SUBJECT: COMANCHE PEAK STEAM ELECTRIC STATION
DOCKET NOS. 50-445 AND 50-446
RESPONSE TO SGEB ADDITIONAL QUESTIONS

Attached are the responses to SGEB Questions 130.37, 130.38 and 130.39 as they will appear in Amendment 53 to the CPSES FSAR.

HILTI KWIK-BOLT TECHNICAL INFORMATION

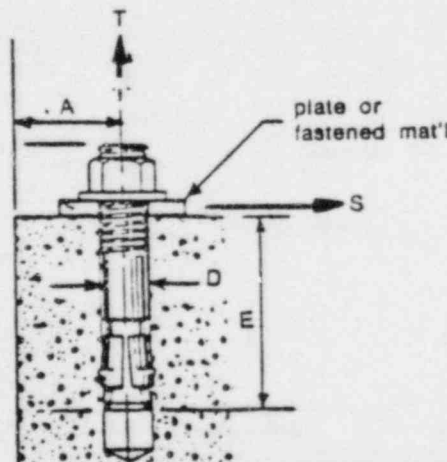
In Cygna's response to CASE's question Walsh #5 and during the ASLB hearing of May 1, 1984, Cygna identified a safety factor of three (3) for the SSE condition as related to Hilti expansion anchors. As part of the justification Cygna referred to NRC Document MS 129-4. This NRC document (MS 129-4) is in a draft form, and has not been converted into a draft NRC Regulatory Guide and/or issued for public comments. Since this guide has not been finalized and recommends a safety factor lower than the manufacturer's recommended safety factor of four, we request that you justify your basis for accepting a safety factor of three. Also, as part of this response you should identify the total number of Hilti expansion anchors used on cable tray supports and the number and locations of expansion anchors that have a safety factor of less than four (4).

The factor of safety on expansion anchors (Hilti Kwik-Bolts) used for Cable Tray Supports has been established to be a minimum of 4 for Operating Basis Earthquake loading conditions (Maximum Working Load Conditions). These loading conditions per the FSAR are considered to be severe environmental loads and will be encountered infrequently during plant life. Steel structures subject to this loading condition are designed based on elastic working stress design methods and meet the requirements of AISC working stress allowables. The expansion anchors which are used with these steel structures have been designed in accordance with the manufacturer's recommendation of a minimum

factor of safety of 4 for the maximum working load conditions, OBE, (copy of Hilti Kwik-Bolt Technical Information, pg. C3, attached).

The factor of safety on expansion anchors used for Cable Tray Supports when subjected to full Safe Shutdown Earthquake (SSE) loading conditions is a minimum of 3. The SSE load per the FSAR is considered to be an extreme environmental load which is credible but highly improbable. The steel structures which are subjected to this loading condition when designed using working stress design methods are allowed to be stressed to a level of 1.6 times the stress of OBE loading conditions. This increased allowable in stress levels is partly attributed to the high improbability of the occurrence of such SSE loading combinations. This same rationale is likewise applicable to the associated factor of safety of 3 for expansion anchors. As provided within the Hilti Kwik-Bolt Technical Information sheet, actual factor of safety to be used depends on the application and should be selected by the designer on this basis. Since the loading condition in question is one of extreme environmental conditions and highly improbable, the lower factor of safety is applicable.
